SUBJECT: ISSUANCE OF AMENDMENTS (TAC NOS. 76715, 76716, 76717 AND 76718)

COMMONWEALTH EDISON COMPANY

BYRON STATION, UNIT NO. 1

Amendment No. 38  
License No. NPF-37

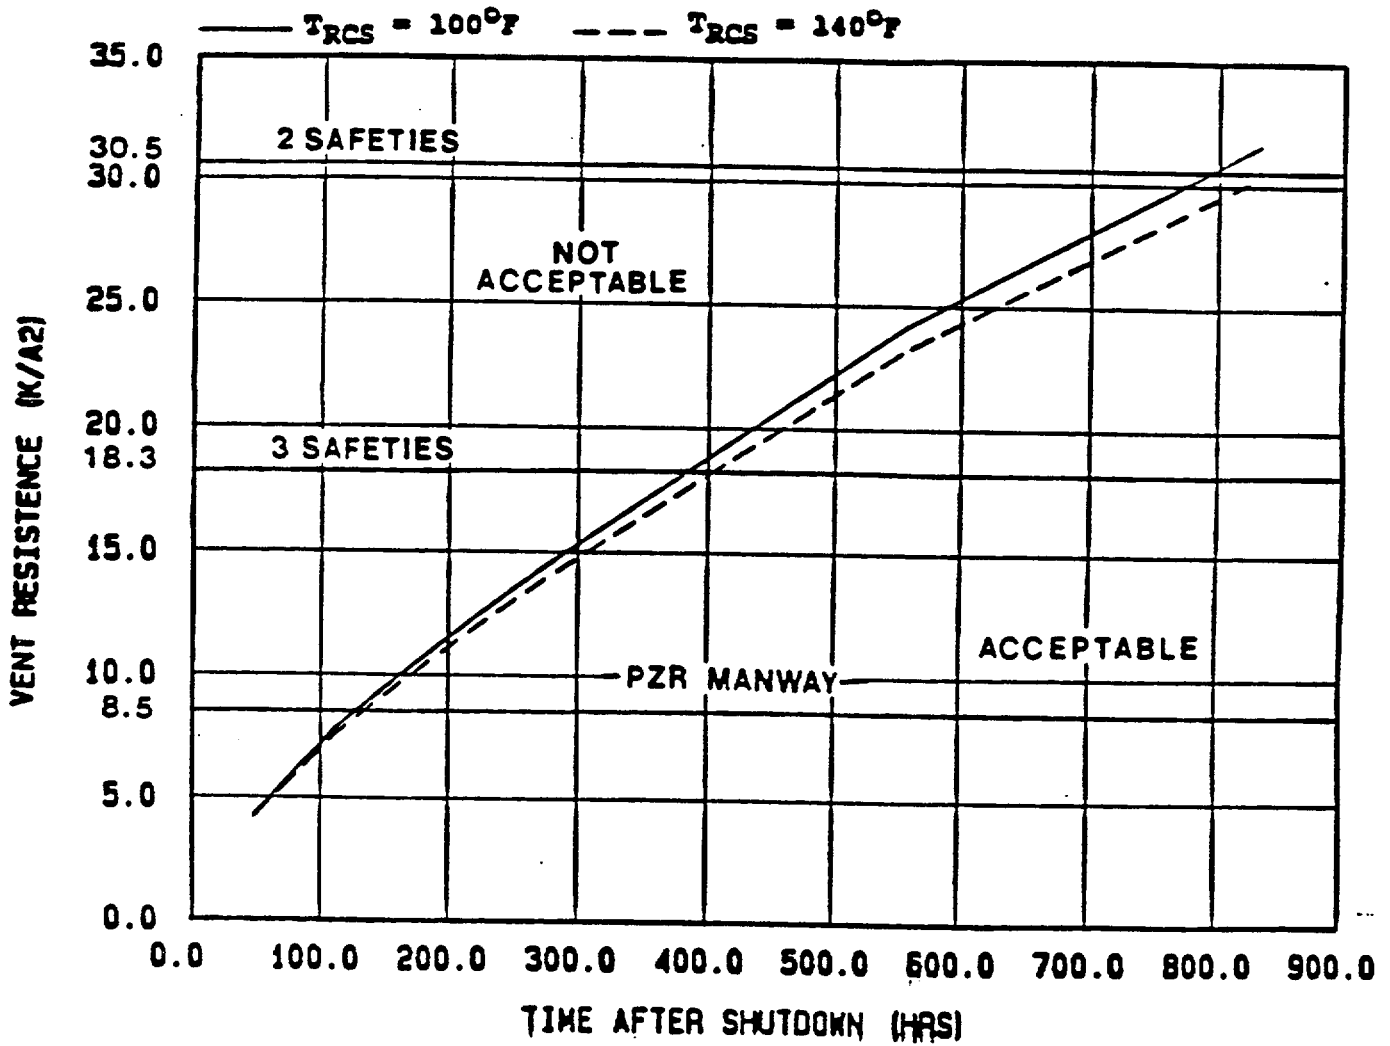
In MODE 5 and MODE 6 with pressurizer level less than or equal to 5 percent, at least one Safety Injection pump or gravity feed from the RWST must be available to mitigate the effects of a loss of decay heat removal during partially drained conditions. Surveillance requirements assure availability, but prevent inadvertent actuation during these modes. The desired flow path for the SI pump or gravity feed varies with RCS configuration and is, therefore, procedurally addressed.

The Surveillance Requirements define what constitutes an adequate hot side vent for various plant conditions. It was determined that removing the reactor vessel head was an adequate vent under all conditions. Other venting alternatives have restrictions based on time from shutdown and RCS temperature. The values in the surveillance were taken from the graph on the following page.

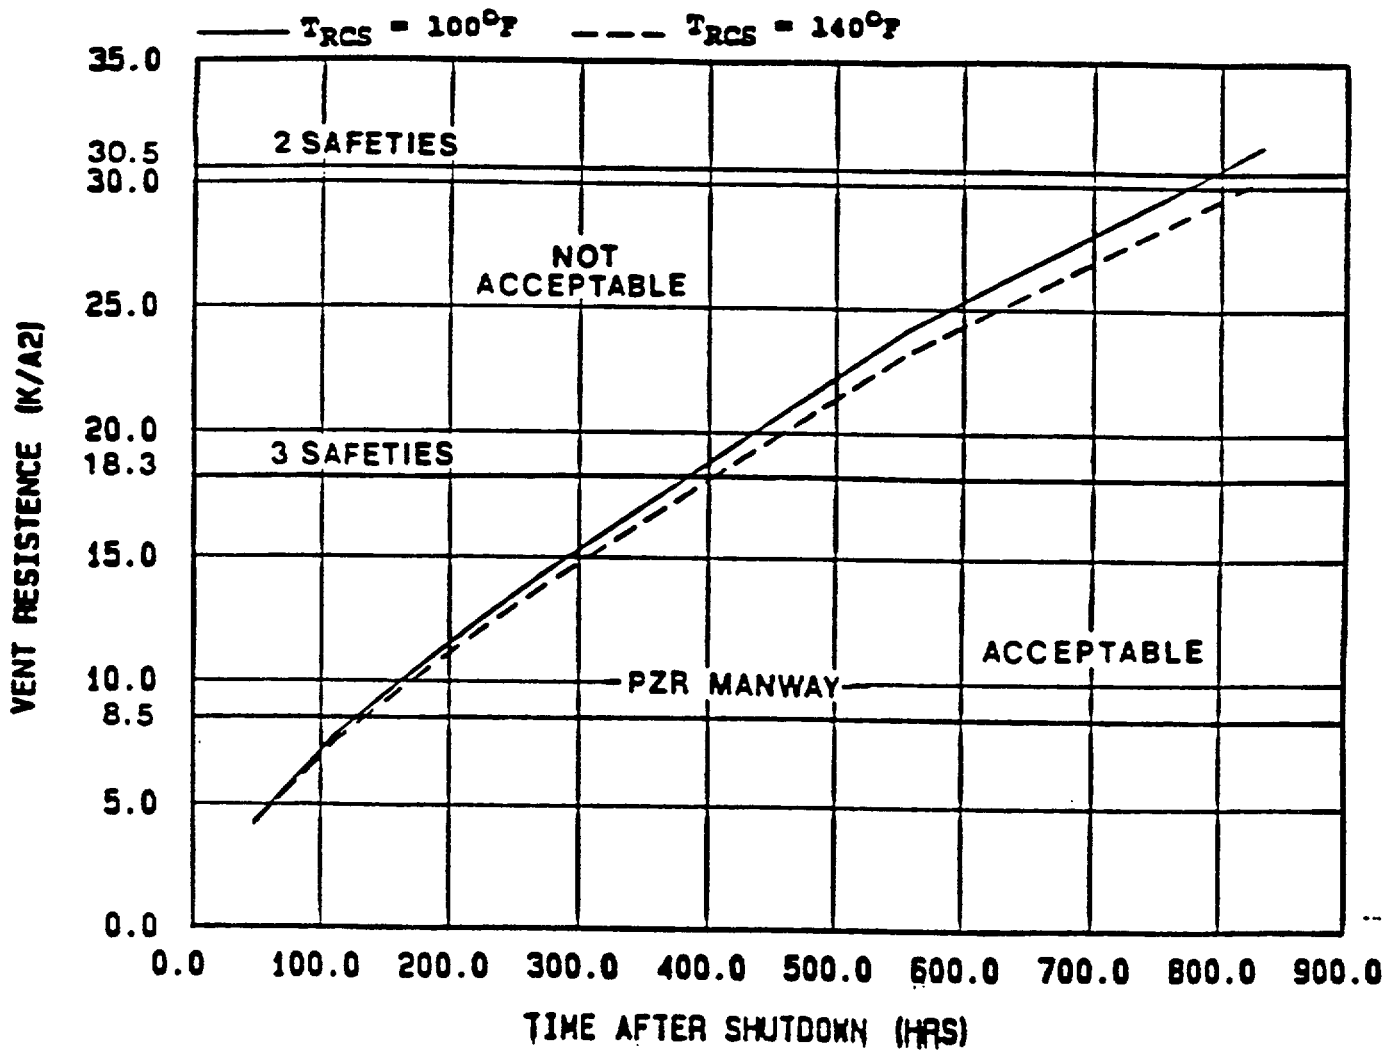
In MODE 5 and MODE 6 with pressurizer level less than or equal to 5 percent, at least one Safety Injection pump or gravity feed from the RWST must be available to mitigate the effects of a loss of decay heat removal during partially drained conditions. Surveillance requirements assure availability, but prevent inadvertent actuation during these modes. The desired flow path for the SI pump or gravity feed varies with RCS configuration and is, therefore, procedurally addressed.

The Surveillance Requirements define what constitutes an adequate hot side vent for various plant conditions. It was determined that removing the reactor vessel head was an adequate vent under all conditions. Other venting alternatives have restrictions based on time from shutdown and RCS temperature. The values in the surveillance were taken from the graph on the following page.
